# TECHNICAL SERVICE BULLETIN

## 10R140 Transmission - Ticking Or Scraping Noise Coming From Bellhousing

**21-2100**  
01 April 2021

Ford 2020-2021 F-Super Duty	Transmission/Transaxle: (10R140)
--------------------------------	----------------------------------

Figure 1

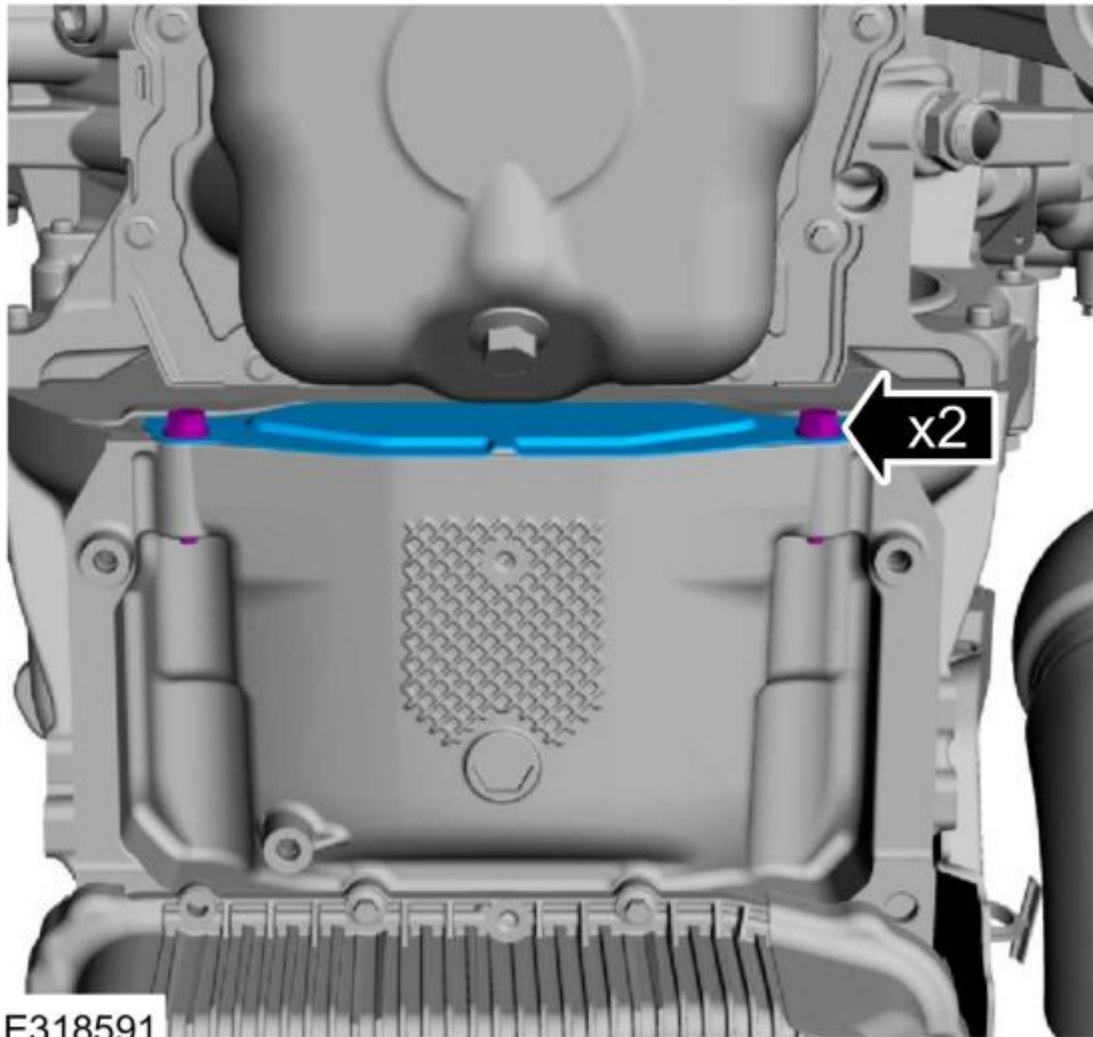
**Issue:** Some 2020-2021 F-Super Duty vehicles equipped with a 10R140 transmission may exhibit a ticking or scraping noise coming from the bellhousing. The noise may or may not go away while in PARK and/or NEUTRAL. This may be due to the torque converter studs contacting the flexplate inspection cover and/or internal torque converter damper spring contact. To correct the condition, inspect and adjust the flexplate inspection cover (gas engine only) and/or replace the torque converter (gas or diesel engine).

- (1). Yes - remove and inspect the flexplate inspection cover for contact with the torque converter studs. If contact is found, adjust the cover so contact does not occur. Refer to Figure 1.
- (2). No - proceed to Step 3.

- E318591
2. Does the vehicle exhibit the condition after adjusting the flexplate inspection cover?
    - (1). Yes - proceed to Step 3.
    - (2). No - repair is complete.
  3. Does the noise go away while in PARK and/or NEUTRAL?
    - (1). Yes - proceed to Step 4.
    - (2). No - this article does not apply. Refer to the Workshop Manual (WSM), Section 100-04 for normal diagnosis.
  4. Replace the torque converter. Refer to WSM, Section 307-01.
